SB #: F101

SUBJECT: WHEEL MOTOR AXLE SHAFT INSPECTION AND NUT REPLACEMENT OF HYDRO-GEAR HGM-“E” SERIES MOTORS PRODUCED BETWEEN SERIAL NUMBER RANGE OF 8076LXXXX AND 9107LXXXX.

Service Bulletin

SUBJECT: Axle shaft inspection and Castellated axle nut replacement.

Figure 1. Inspecting the Castle Nut

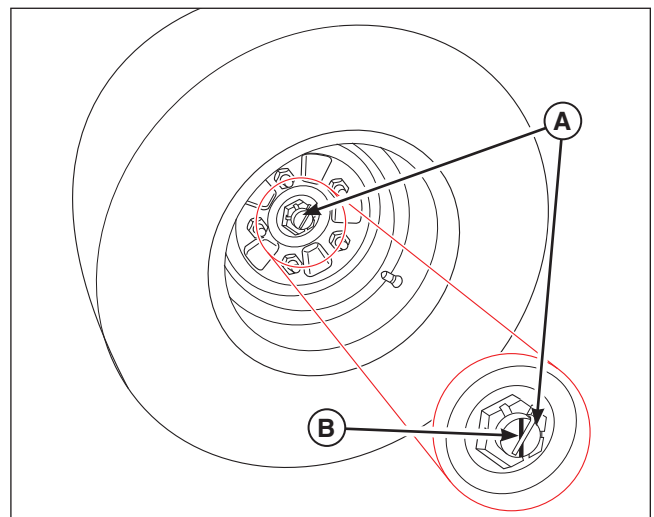
1. Park the machine on a flat, level surface. Disengage the PTO, engage the parking brake and turn off the engine.
2. Inspect the wheel motor axle shaft and nut. If the end of the wheel motor axle shaft and nut has a paint pen mark on it, no further action is required. **If the wheel motor axle shaft and nut does not have a paint pen mark on it, continue with Step # 3.**

Figure 2. Locating the Wheel Motor Serial Number
A. Wheel Motor Serial Number

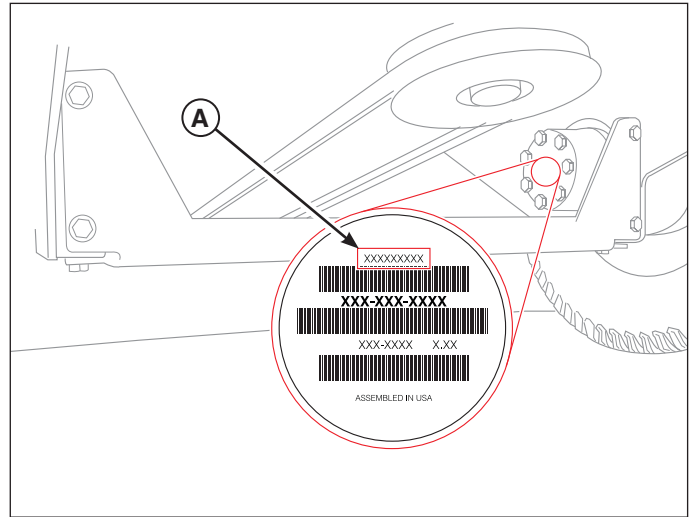
3. Refer to Figure 2. Inspect the serial number of the wheel motor. **If the serial number falls in the range of 8076LXXXX - 9017LXXXX, continue with CORRECTIVE PROCEDURES.** If the serial number does not fall in the range of 8076LXXXX - 9017LXXXX no further action is required.
4. Repeat this process for the other side of the unit.

1. Order and install kit part number 5600346.
2. Repeat this process on the other side of the unit, if the wheel motor falls within Hydro-Gear wheel motor serial number range of 8076LXXXX - 9017LXXXX.
3. Record the serial number of each wheel motor updated. See **Warranty Information**.

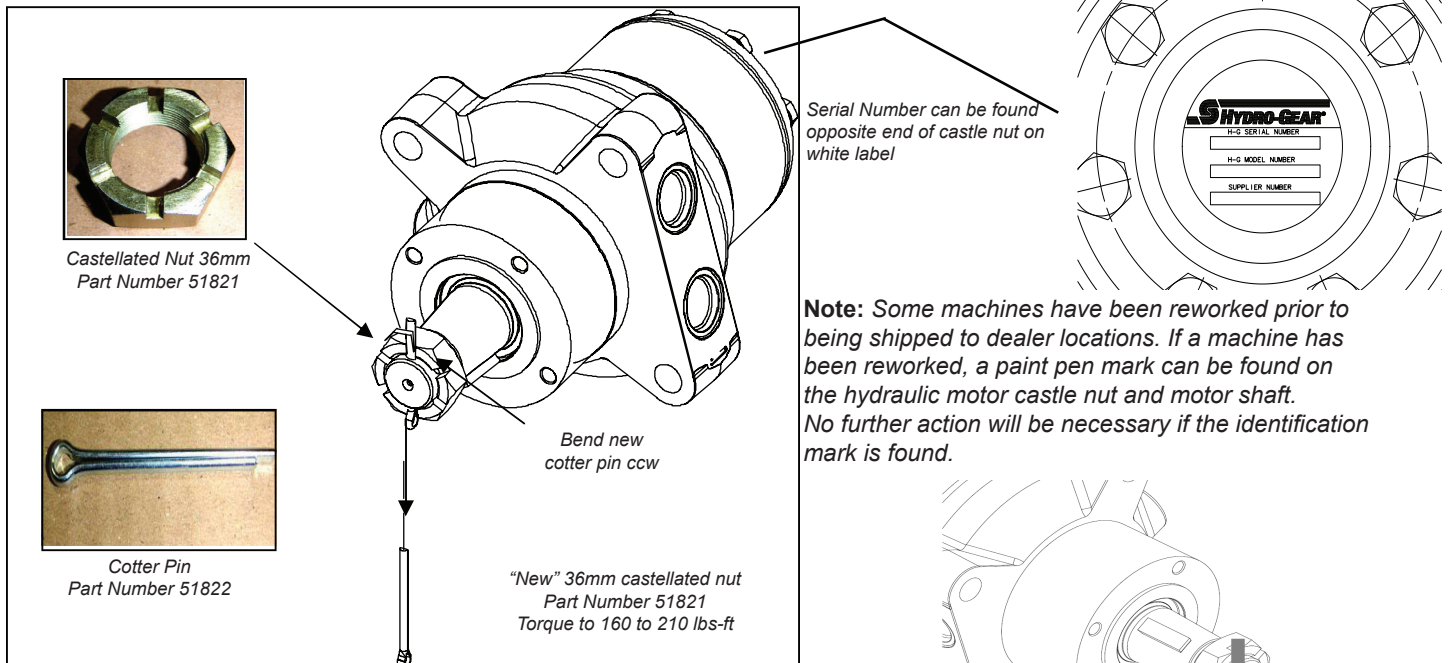
2. Remove the cotter pin, and the castellated nut. Discard both parts as they will not be re-used.

3. Install the new castellated nut manually with ratchet and socket and torque to 160 lbs-ft. (Increase torque until pin can align with hole in axle.)

4. Install new cotter pin, bend long cotter pin leg counter clockwise to mate with the castellated nut flat.

Figure 2. Installing the New Cotter Pin and Castellated Nut

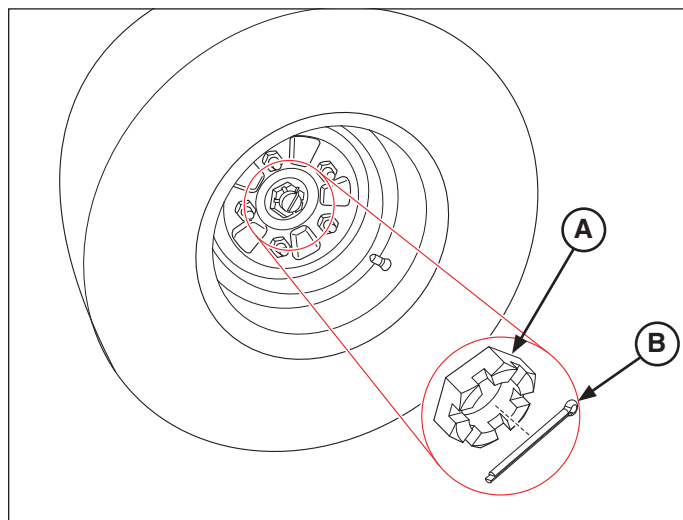
1. Park the unit on a smooth, level surface such as a concrete floor. Disengage the PTO, engage the parking brake, turn off the engine, and remove the ignition key.
2. Chock the wheels of the unit to prevent movement.
3. Position jack stands under both side of the rear of the machine. **Do not raise the unit.**
4. Remove the cotter pin (B, Figure 1) and the castellated nut (A). Discard both parts, they will not be reused.
5. **If there are any signs of obvious damage to the tip of the wheel motor shaft, contact our Service Department at 1-800-933-6175 ext. 709.** If there is no evidence of damage continue with step # 6.
6. Install the new castellated nut on the wheel motor. Torque the castellated nut to 140 ft. lbs (190 Nm). Increase the torque until the cotter pin can align with the hole in the wheel motor axle shaft.

6. Install the new cotter pin. Bend the long cotter pin leg COUNTER-CLOCKWISE to mate with the castellated nut flat.
7. Repeat process for other side of unit.
